Date: 27/07/2020
Author: Michal Galuska
SUBJECT: SAFETY ALERT RNQI20-16 + STOP SHIPMENT – Safety risk gas stop valve Split outdoor units

UPDATE 23/09/2020 – TO BE SHARED WITH AFFECTED CUSTOMERS

With this rapid news we want to inform you of a possible safety risk with the gas stop valves on some split outdoor units of the BML-H range, produced in the month June & July 2020.

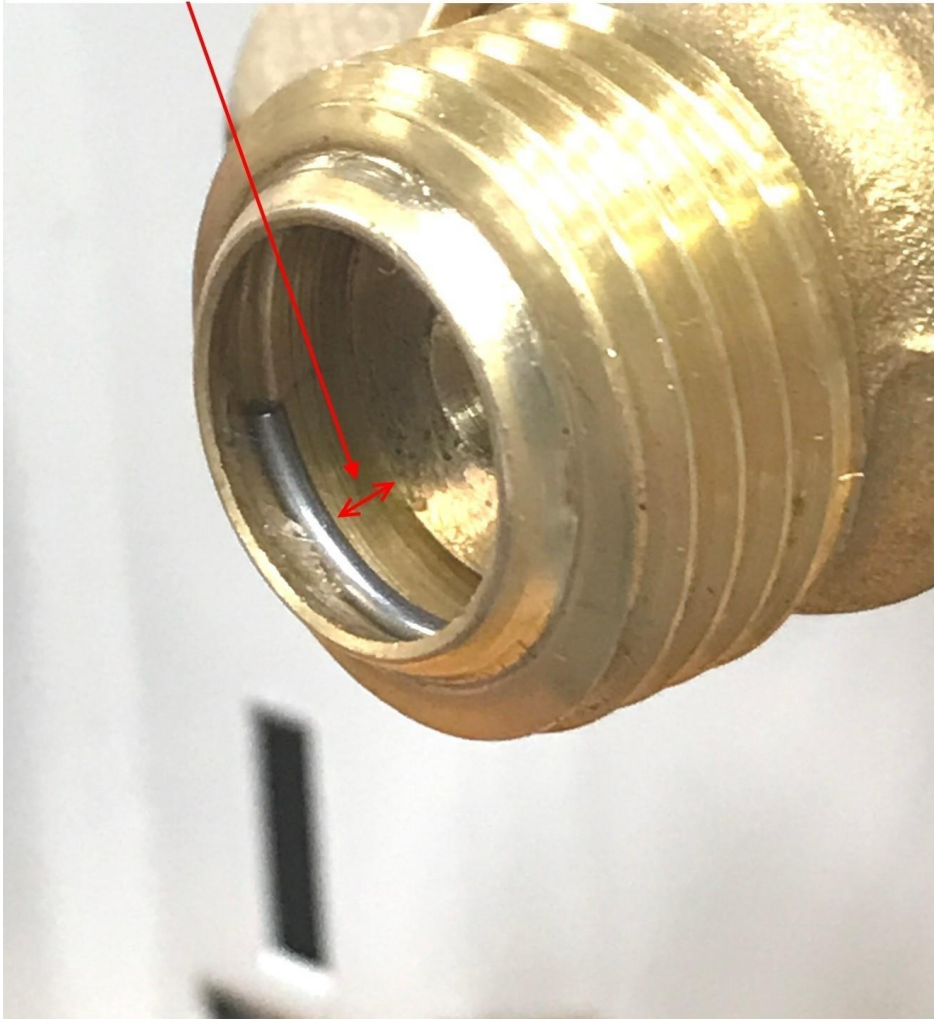
When opening the stop valve, there is a possibility that a part of the thread comes loose. If in this situation the installer continues to further open the valve, the stem of the valve could be ejected out of the valve with a high force and cause sudden release of refrigerant out of the unit. There is a risk for the person opening the valve to be hit by the valve stem or to suffer refrigerant burn marks.

Not yet installed units should not be commissioned, unless it can be assured that **maximum valve opening is limited to 10 complete rotations of 360°**. At 13 rotations the valve stem could come loose, normal full opening position is 11.5 rotations. As required during any service operation, please make sure to wear personal protective equipment such as safety glasses, safety gloves, safety shoes, etc... When putting back the original valve cap, only hand tighten it. [See Appendix!](#)

3 Cut-away view of the stop valve:

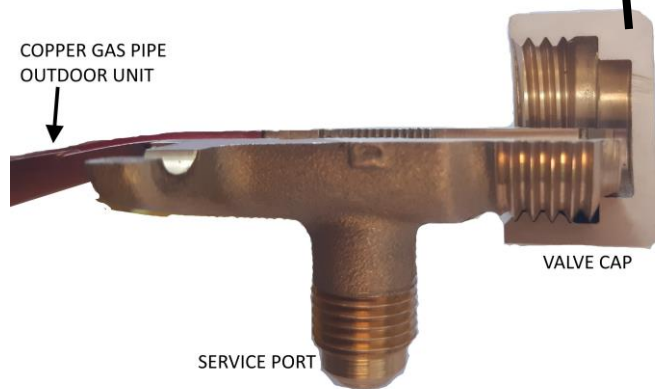
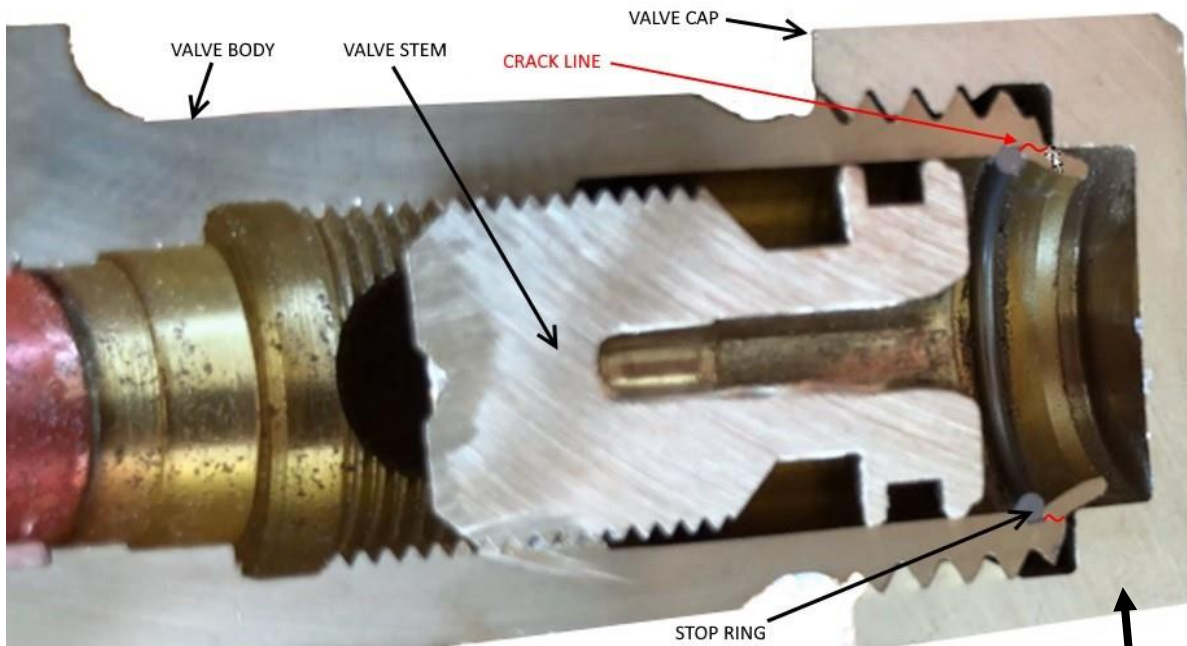
CAUTION !**MAXIMUM OPENING IS 10 ROTATIONS**

Turn clockwise to make sure valve is fully closed, then turn counter-clockwise for maximum 10 rotations !

The valve stem should not touch the stop ring !

Too small inside diameter of the valve cap will cause a crack to the valve body when tightening the valve cap. When opening the valve stem, the top part of the valve body can fall off and release the stop ring. If the valve is then opened more than 13 rotations, the valve stem can be pushed out of the valve body with big force.

Hydraulic pressure test up to 220 bars have confirmed that the valve stem stays in place when opening the valve to a maximum of 10 rotations.
